Project: LODI UNIFIED SCHOOL DISTRICT
BEAR CREEK HIGH SCHOOL RESTROOMS MODERNIZATION

ADDENDUM 1

10/26/2023

A40.2

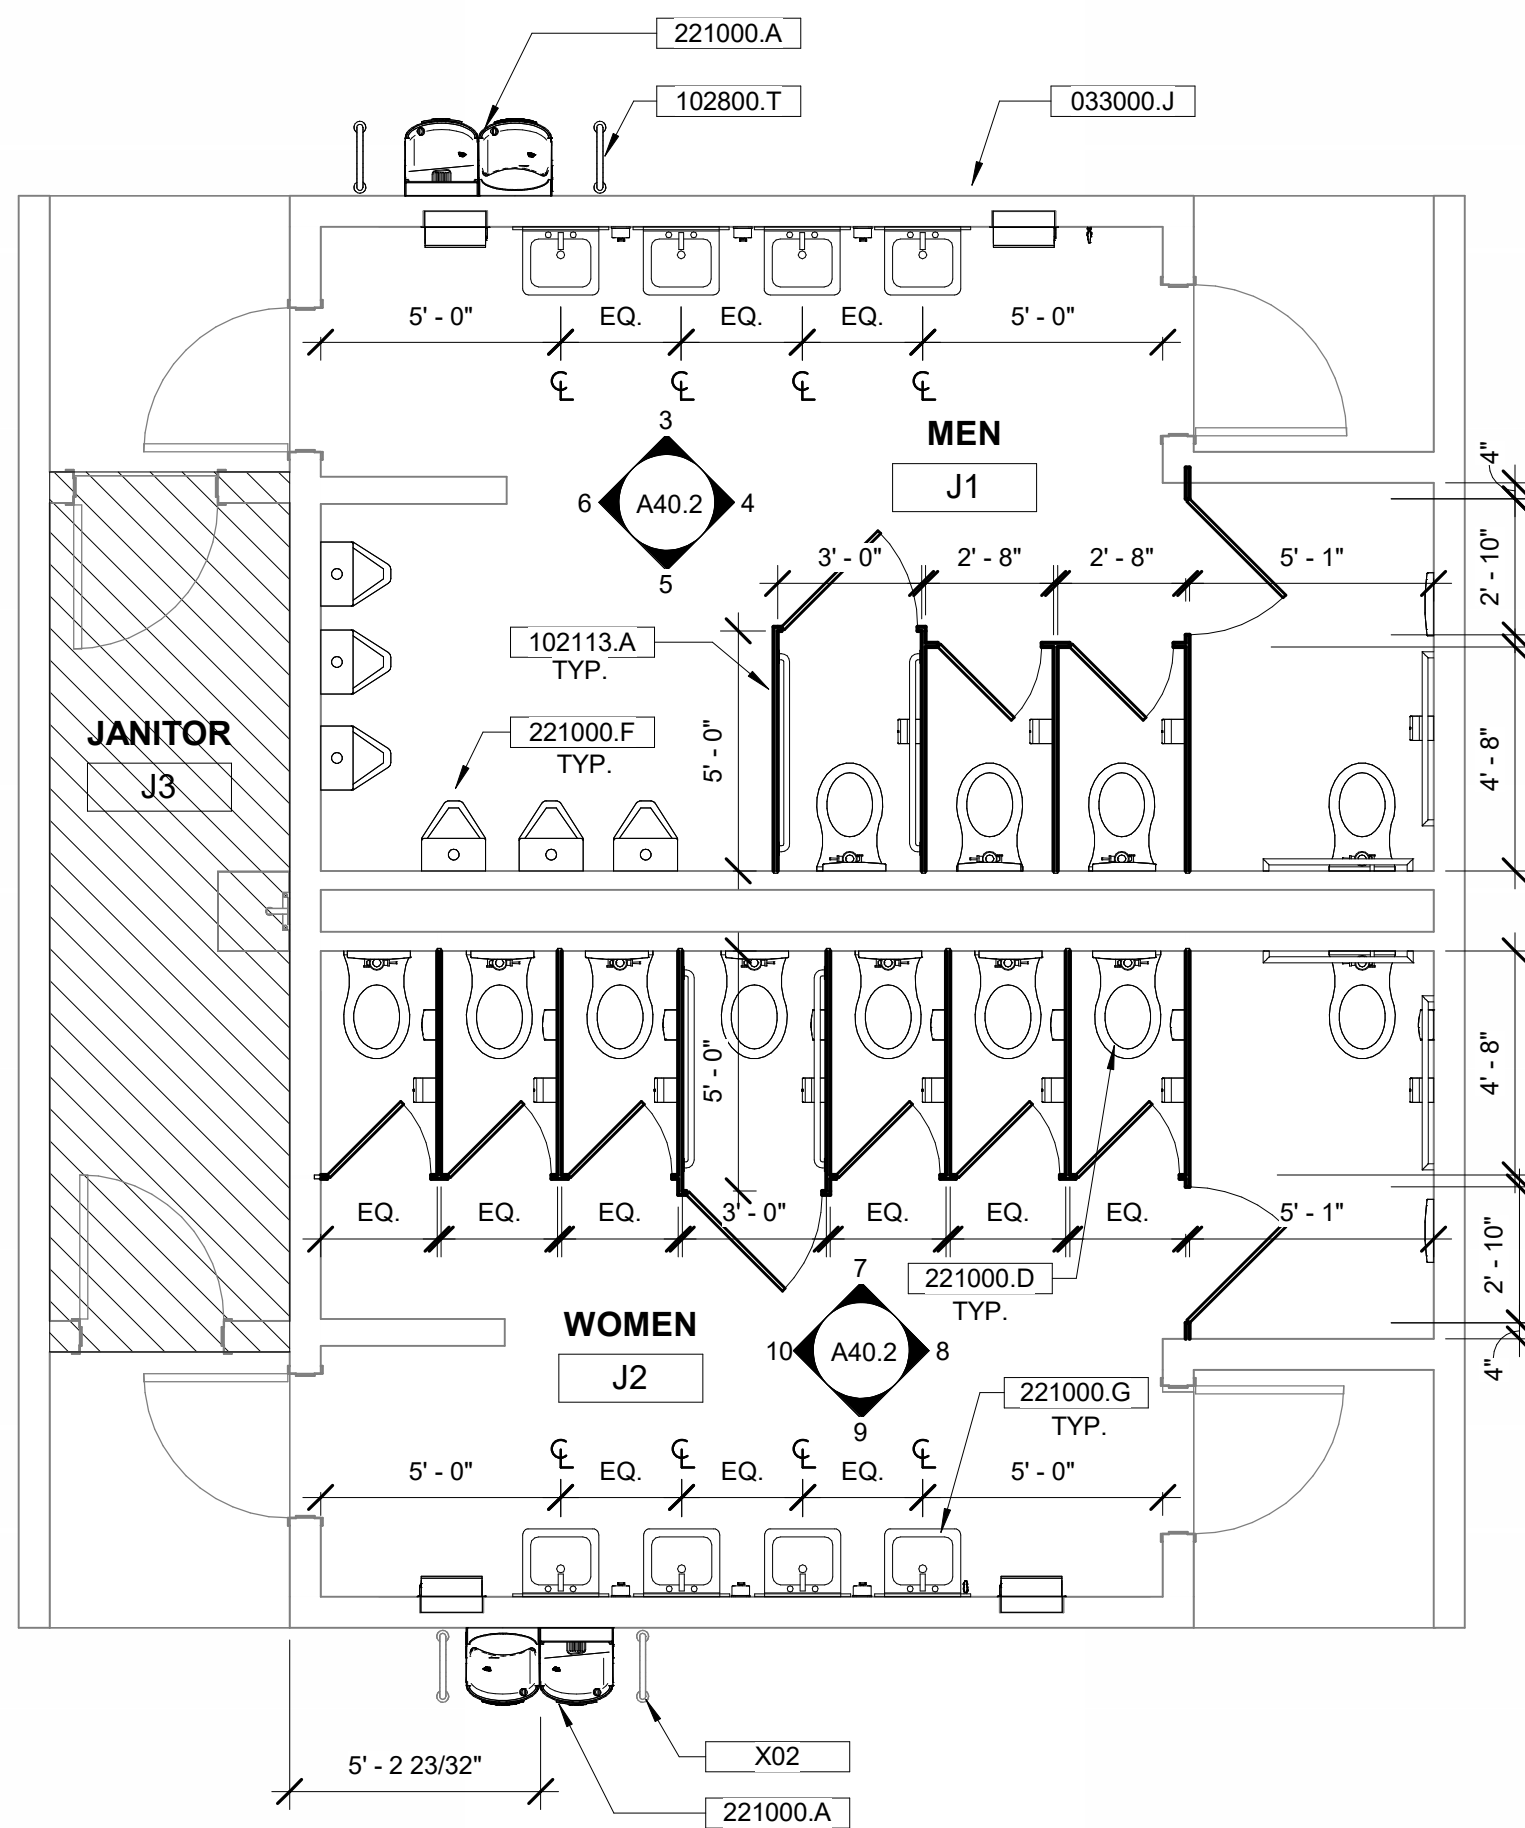
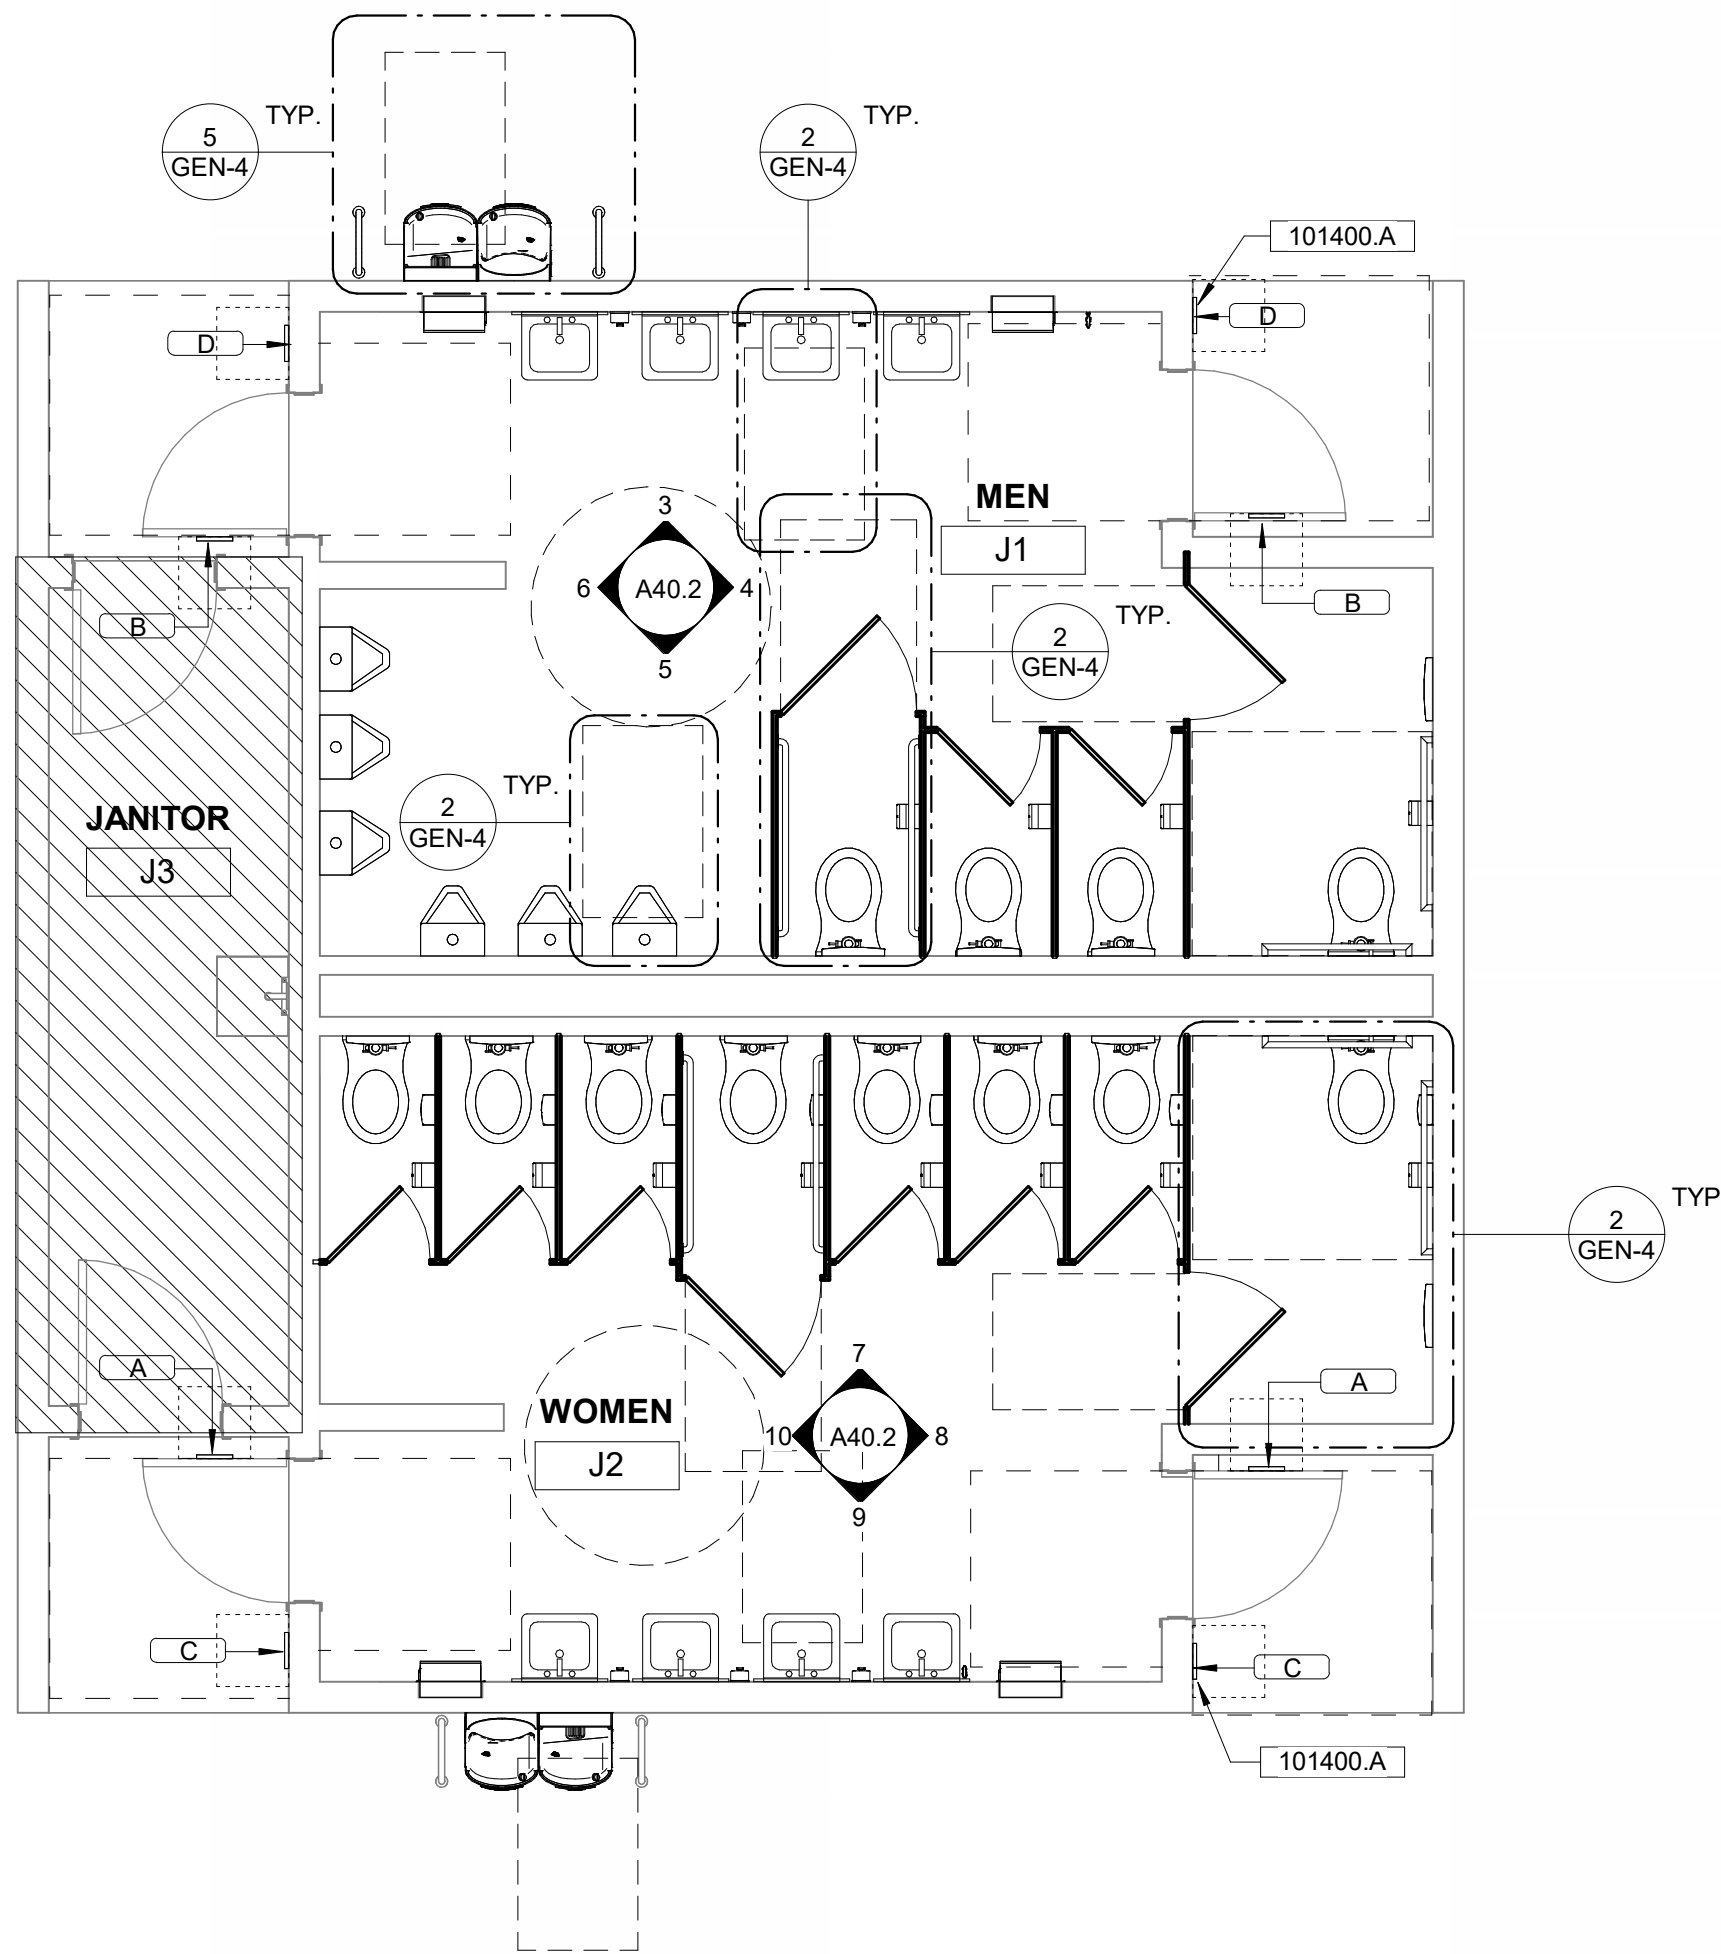
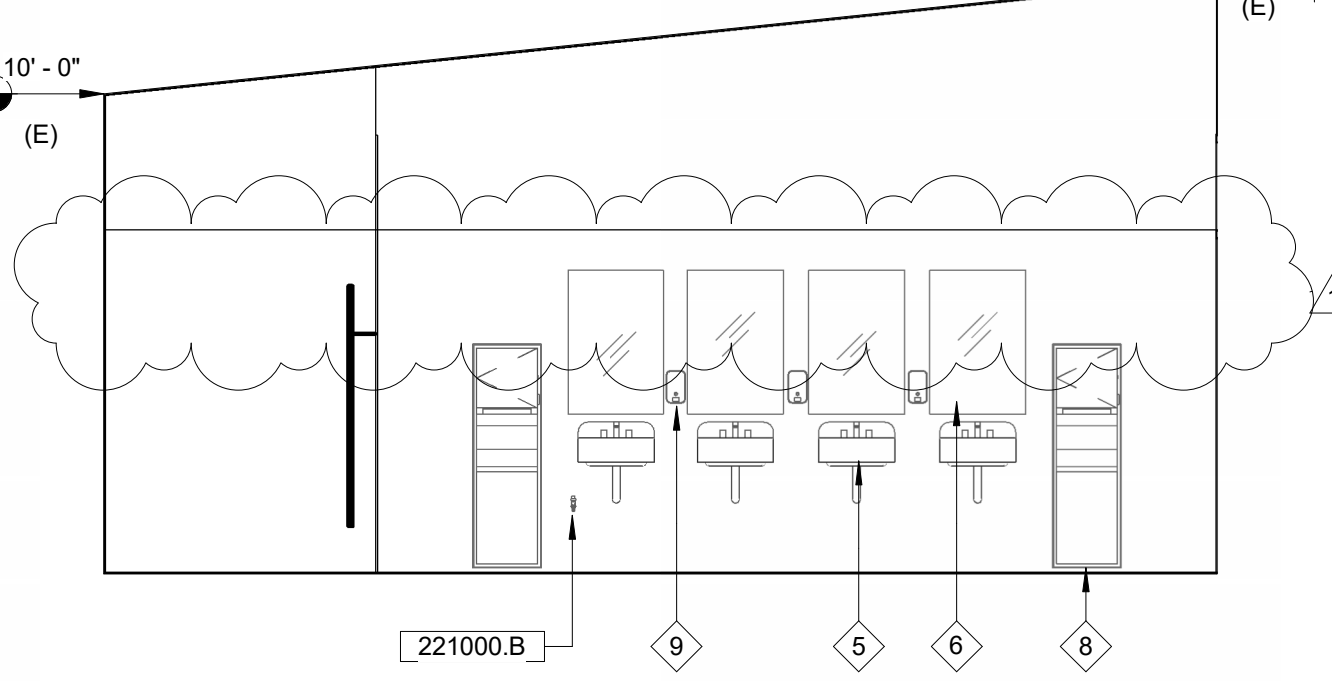
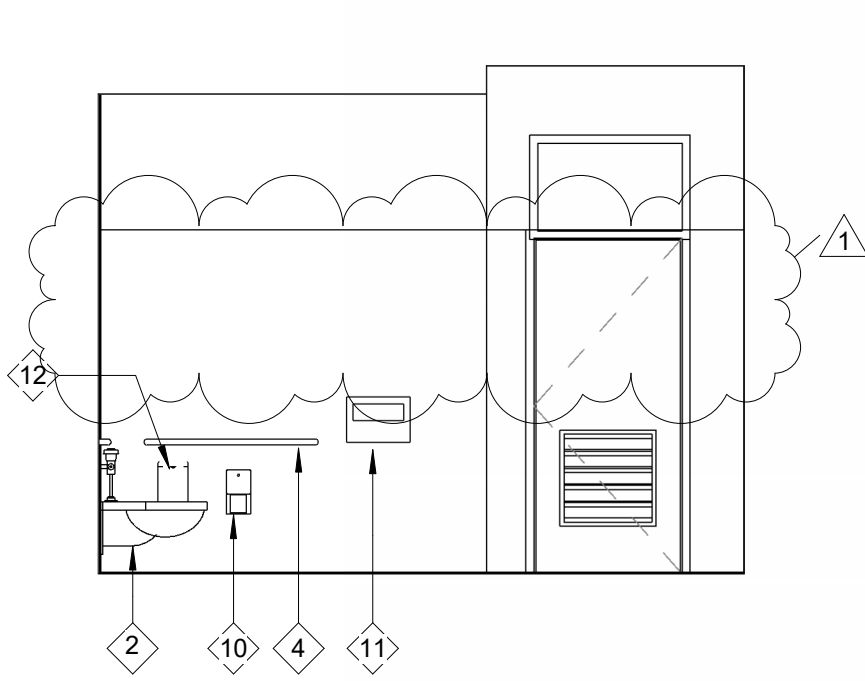
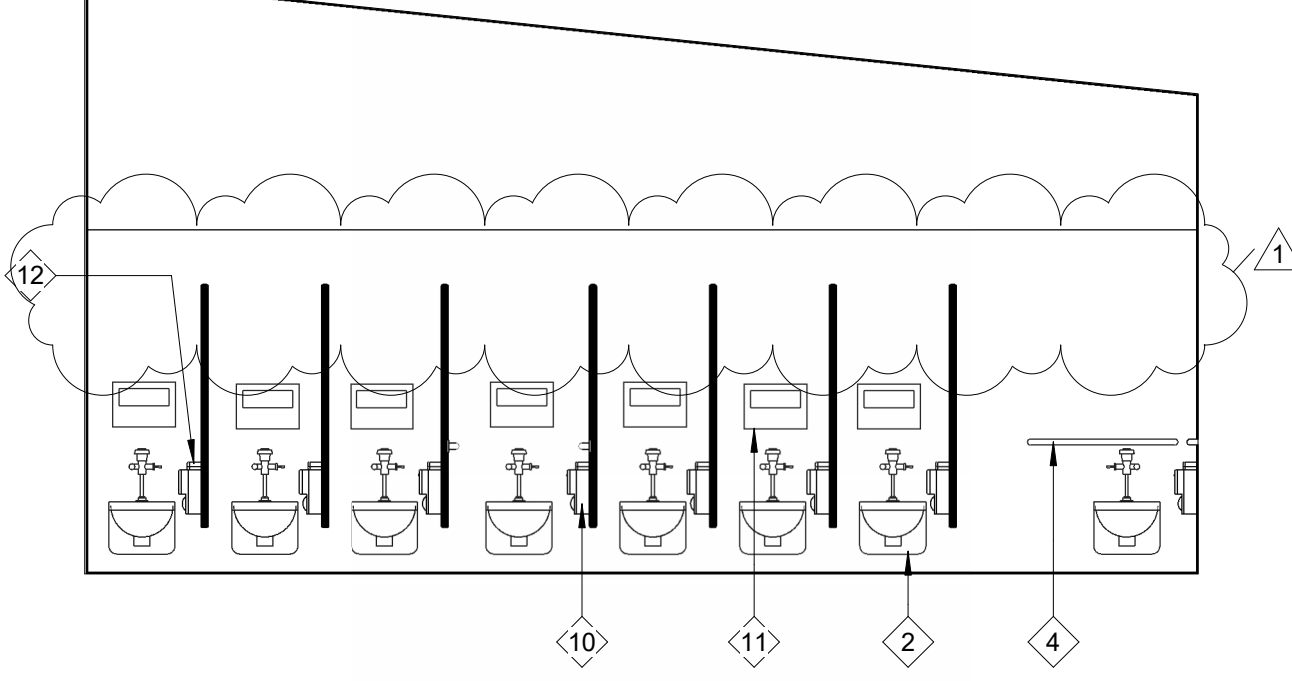
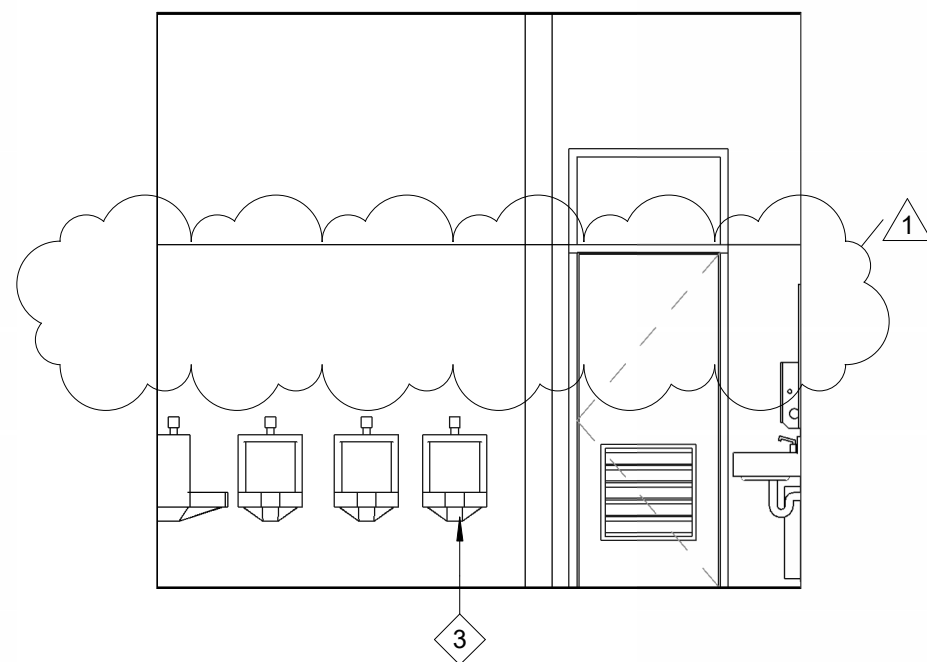
- C. A40.2: Building J – Enlarged Plans & Interior Elevations
 - a. Restroom Accessory Legend note 1 revised to call for solid plastic toilet compartment partitions

- b. Remove keynote 096513.A
 - c. Show epoxy wainscot to +7'-2" with painted gypsum board above (no FRP)
- D. A40.4: Building Q – Interior Elevations
 - a. Restroom Accessory Legend note 1 revised to call for solid plastic toilet compartment partitions
